**Re: Second Submission Review** – Aurora Technology and Energy Corridor (ATEC) – Master Plan  
Application Number: **DA-2214-00**  
Case Number: **2020-7001-00**

## *Second Submission Review*

<b>Project Name:</b>	Aurora Technology and Energy Corridor (ATEC) – FDP (RSN: 1420862)
<b>Location:</b>	North of 26 <sup>th</sup> Ave, between Monaghan Mile Road and Powhatan Road
<b>Drainageway:</b>	First Creek Watershed, Second Creek Watershed, Box Elder Creek Watershed

**Re: Aurora Technology and Energy Corridor (ATEC) Master Plan – 2<sup>nd</sup> referral  
Case # DA-2214-00**

**P831278 Plat Review 48thAve/26<sup>th</sup> Ave ATEC-1420862 Aurora, CO**

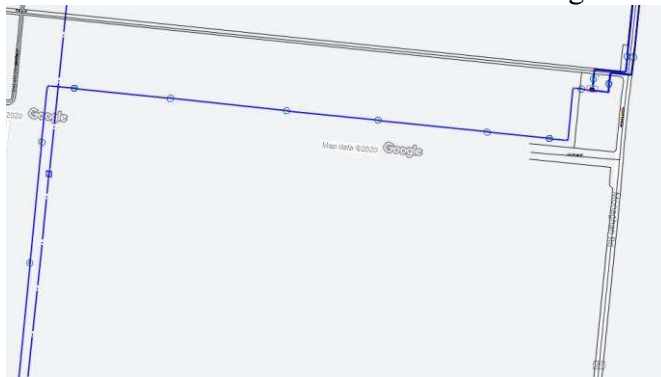
There are some facilities in this area that might be in conflict.
